NOTICE OF PROPOSED DEVELOPMENT

4 OCHRE COURT, DODGES FERRY

DWELLING AND OUTBUILDING

APPLICATION NO: 5.2025-340.1
DATE: 12 JUNE 2026

DESIGN	PAUL WAKELAM	A_01.02.26
SCALE	1:200	DATE
DRAWN	paw	01.04.25
DRAWING	A1.2

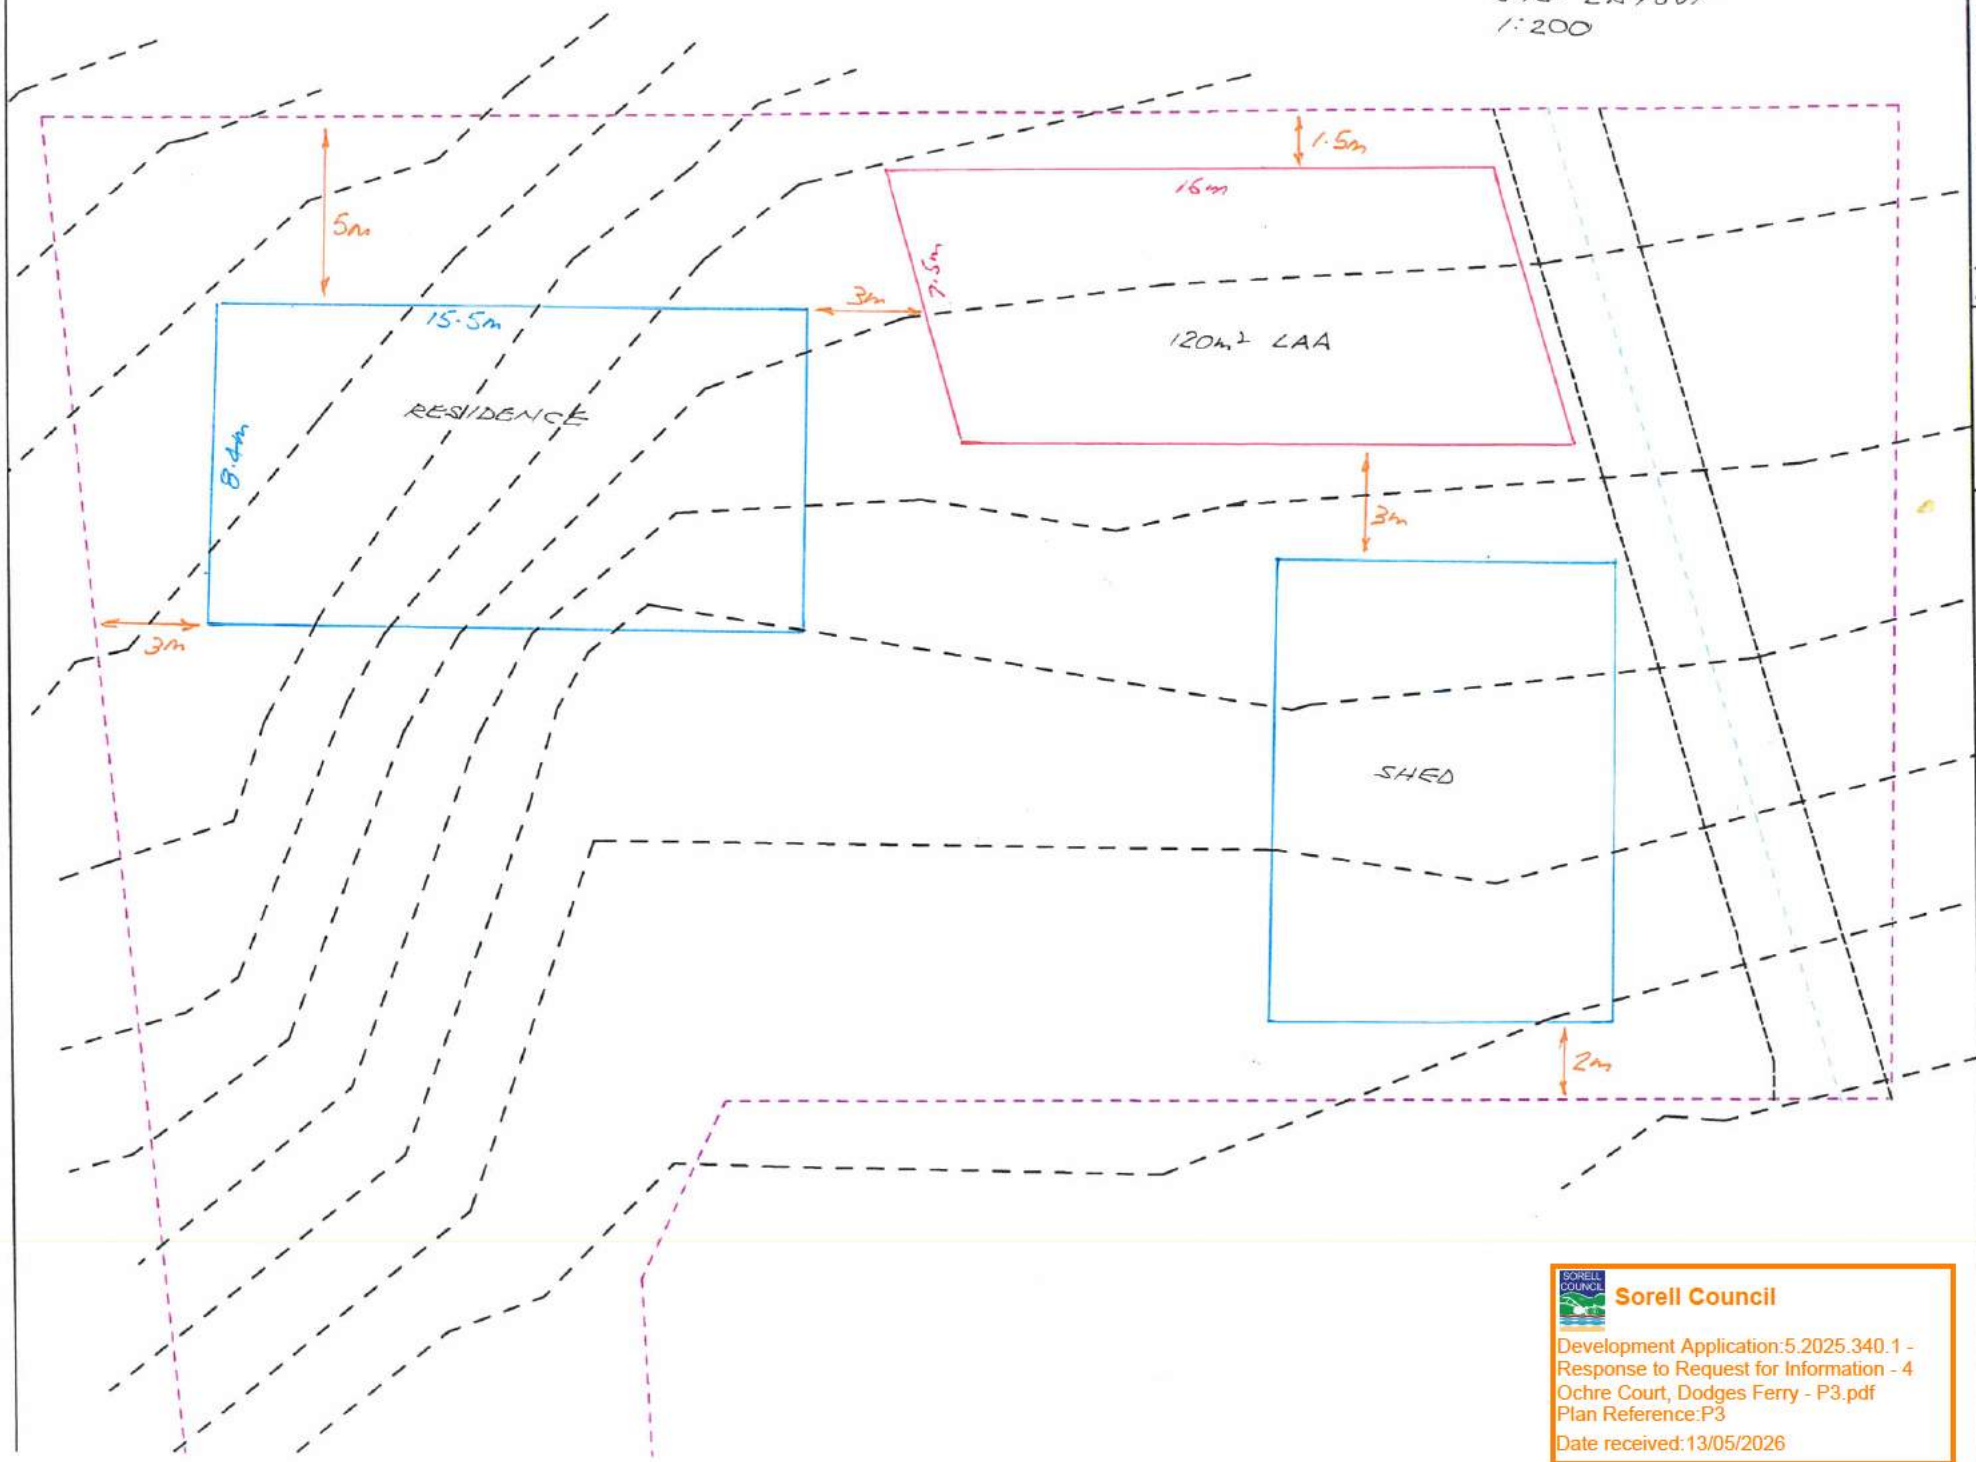
4. Please provide an offset from the stormwater main for the proposed new shed in accordance with Council Stormwater in New Development Policy.

5. Please provide lot connection to reticulated main in accordance with Council's Stormwater in New Development Policy.

7. Provide a stormwater design that demonstrates compliance with SOR – S2.7.2 A1 or P1 – Southern Beaches On-Site **Satisfied**

4. Refer to drawing A1.2C for 1m setback from stormwater main pipe. **Satisfied**

5. Refer to drawing A1.2C for locations of pits and stormwater piping to main storm water drain located on site. **Satisfied**

7. Refer to drawing A1.2C Site plan for stormwater layout compliant with SOR-S2.7.2 A1. **Satisfied**

SCALE 1:100	DRAWING DRAWN paw A2.0

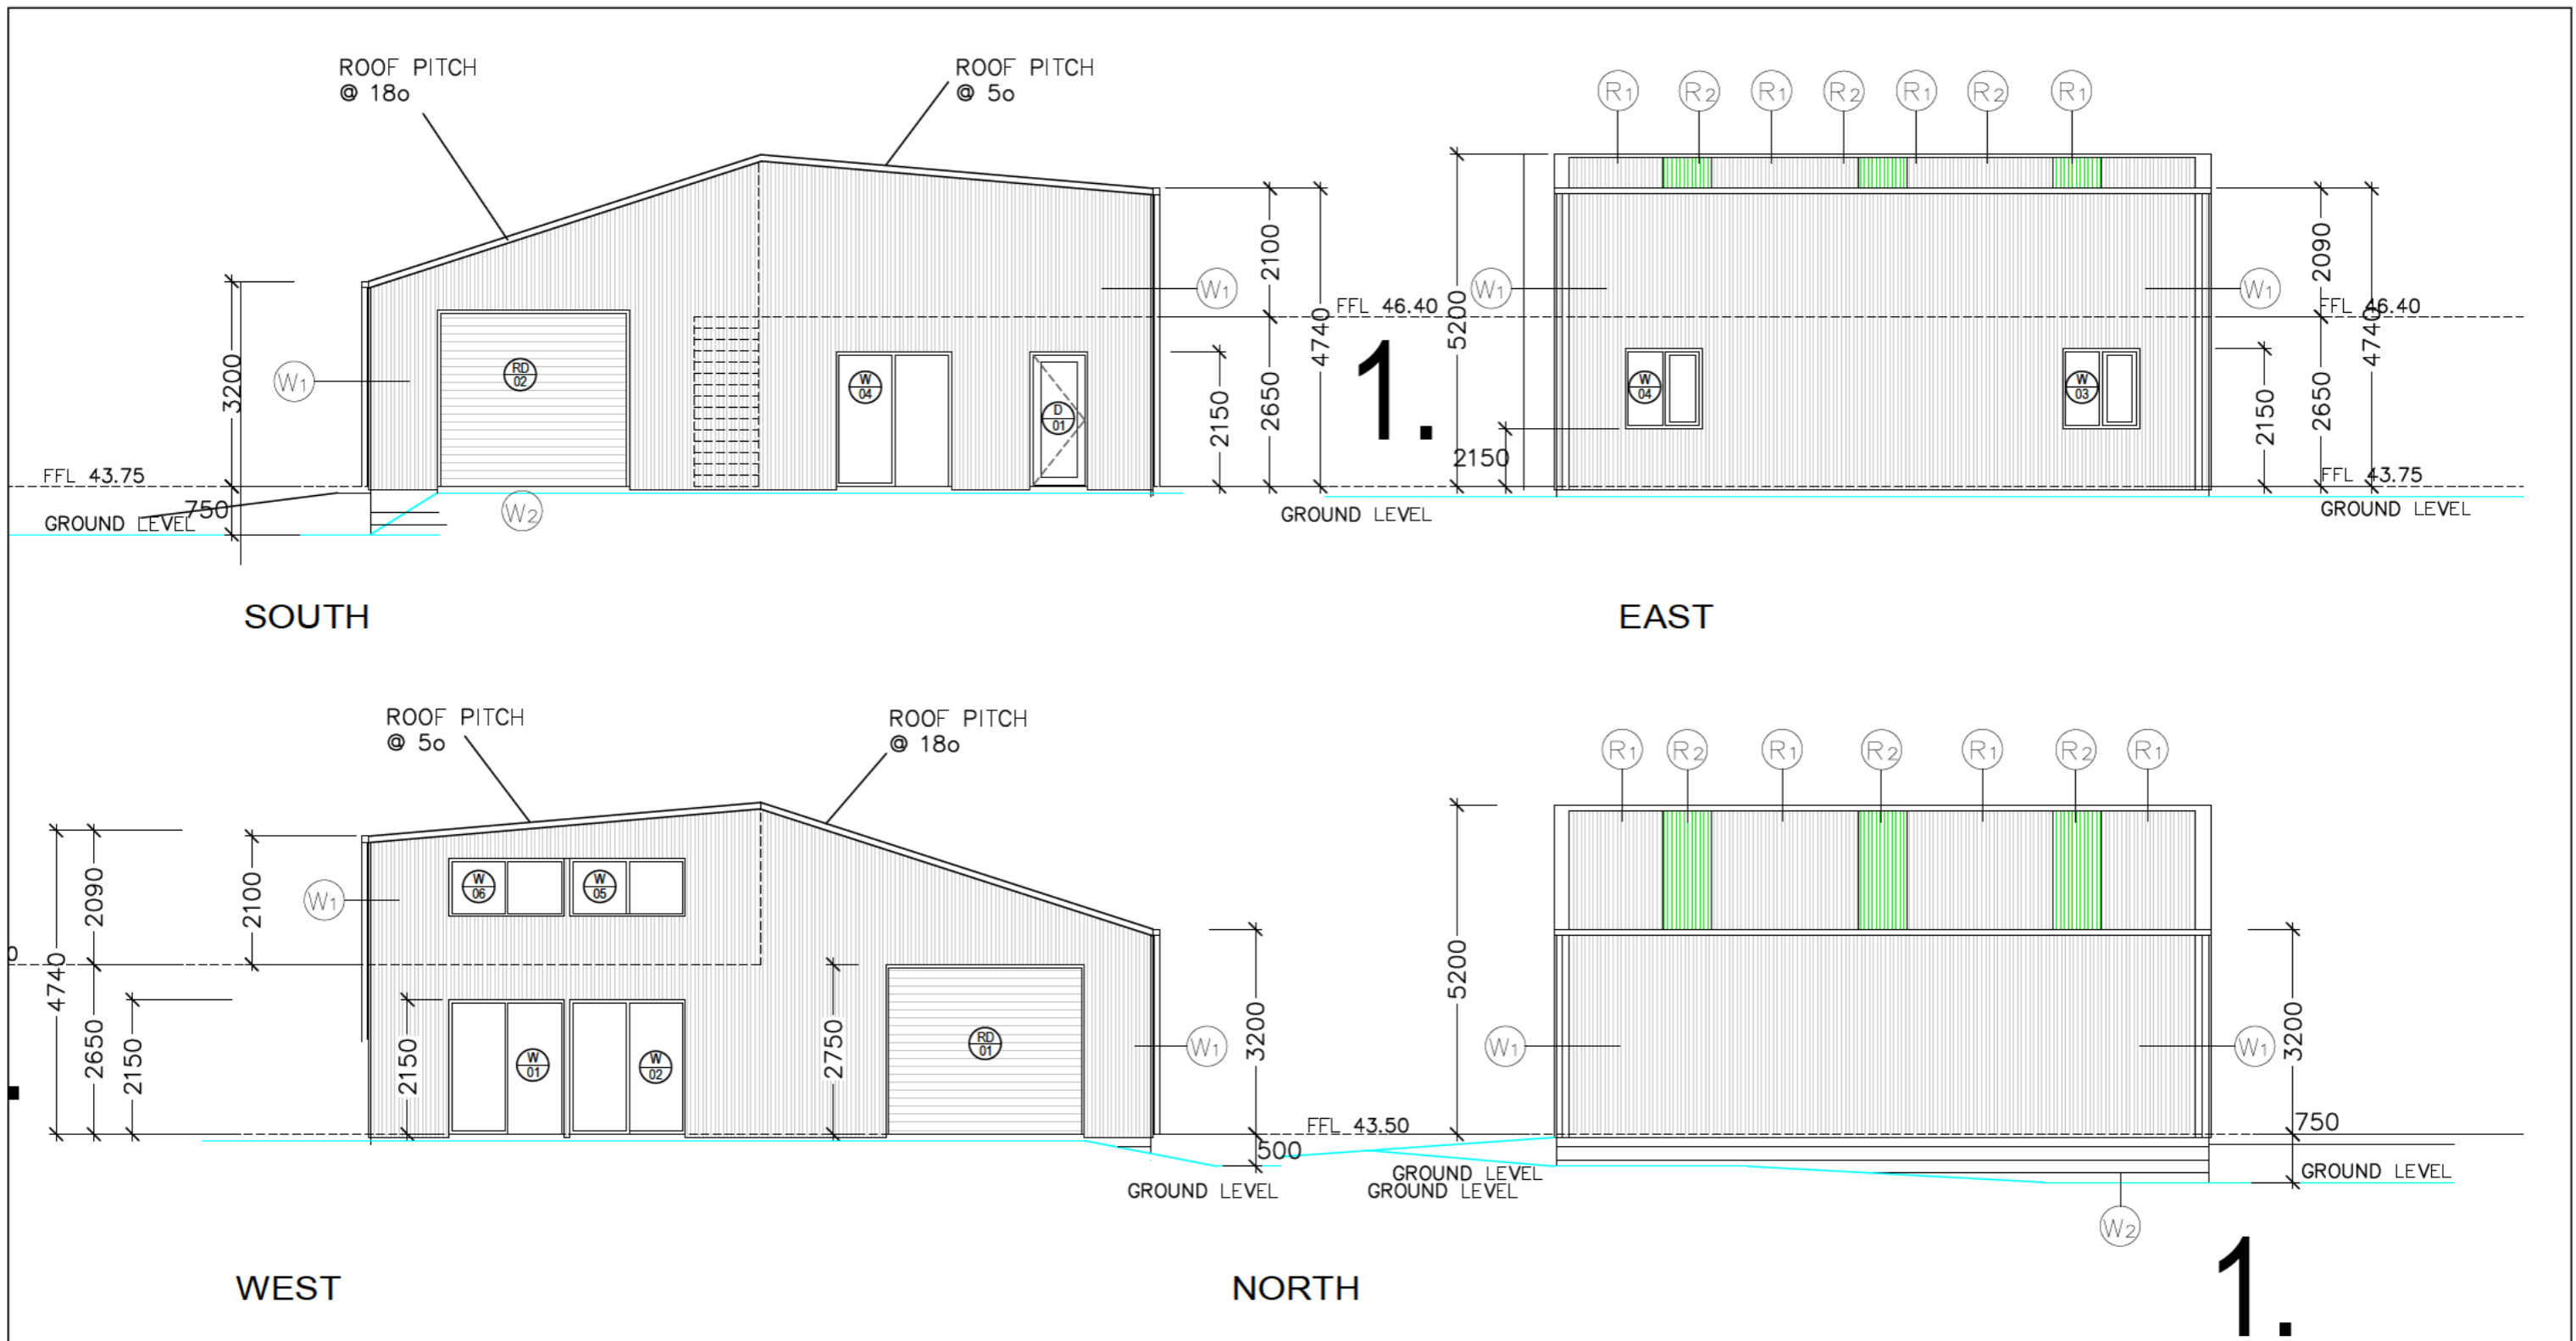
1. Amended elevations of the proposed outbuilding that include reference to natural ground level and show both the proposed wall height and maximum building height. **Satisfied**

1. Refer to drawing A2.0C & A2.1C for wall heights and max building height for out building (shed). These had to be adjusted in relation to Soil and Waste Water System Design Report.

SHADOW PLAN	SCALE NTS	DATE 01.04.25			DRAWN paw	DRAWING A1.3

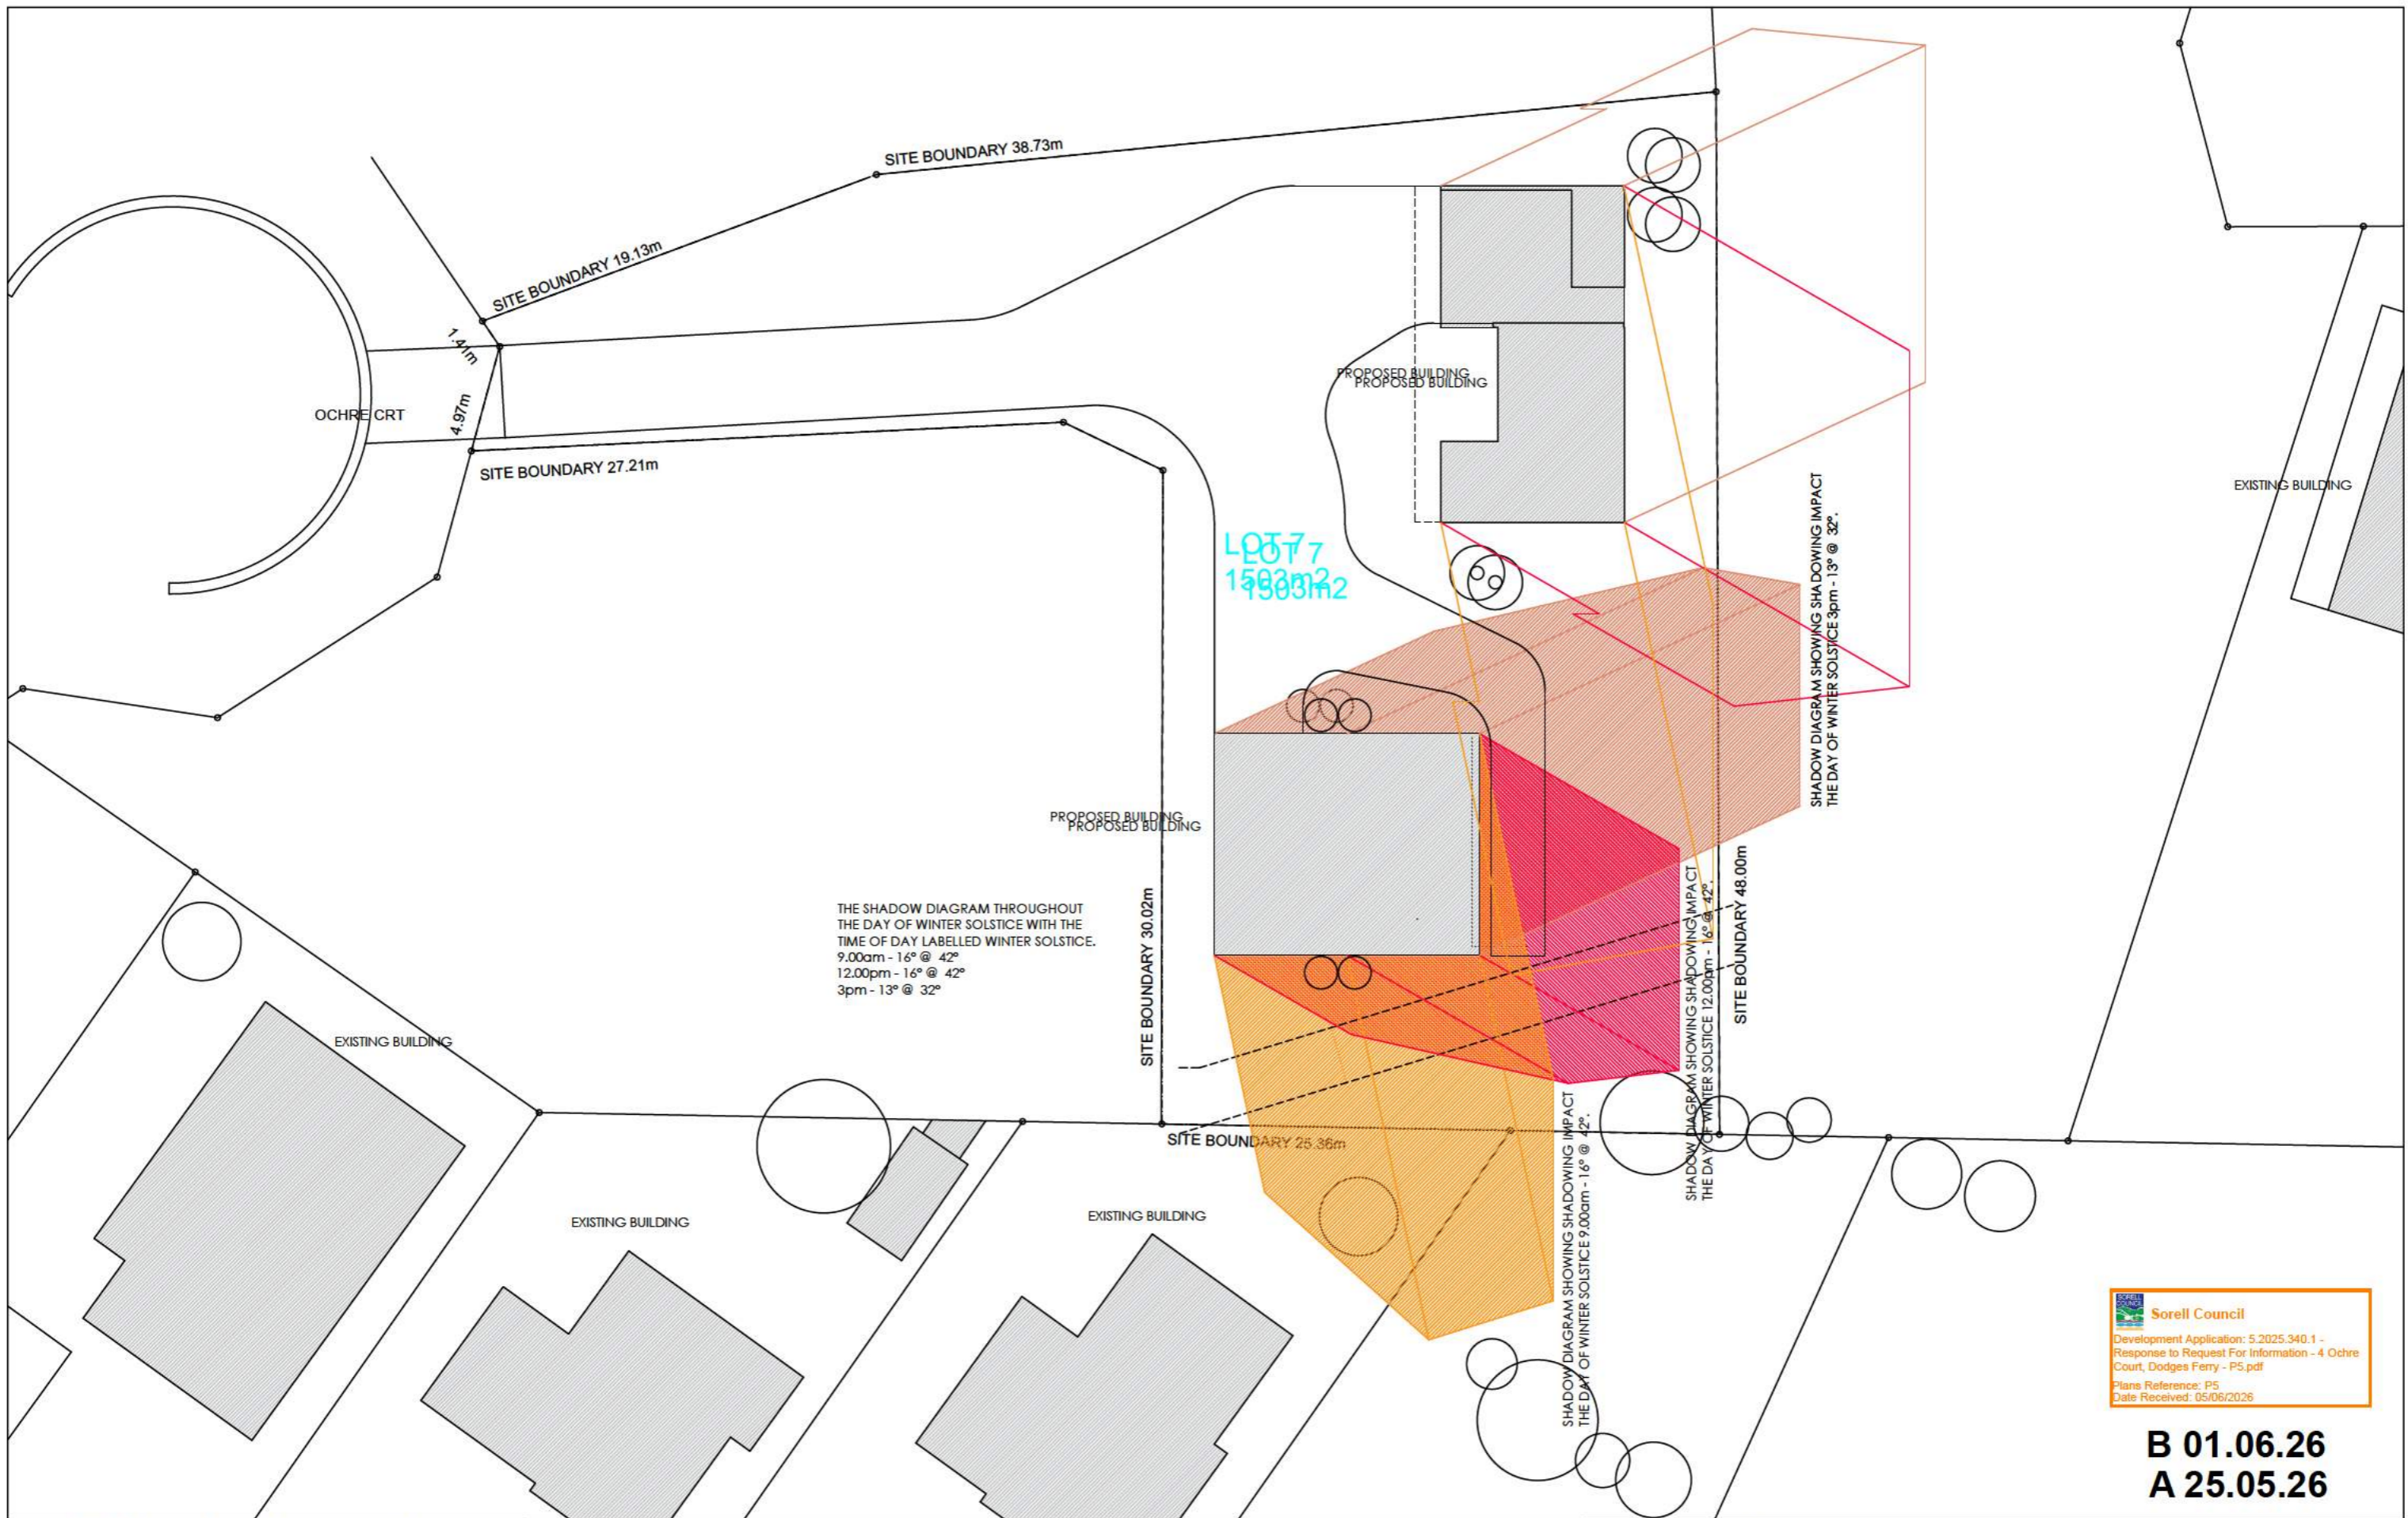
Documentation to address the requirements of Clause 10.4.3 (P2) of the Tasmanian Planning Scheme – Sorell (the Scheme) for setback, specifically in that diagrams to show the likely extent of overshadowing to occur at Winter Solstice because of the proposed outbuilding are required.

Not Satisfied – this requirement remains, and updated shadow diagrams are required that show how the shadowing from both revised buildings would impact adjacent land at the winter solstice.

Please find attached Drawing A1.3 Shadow Plan for outbuilding as requested for extent of overshadowing on the winter solstice at 9am, 12pm and 3pm.
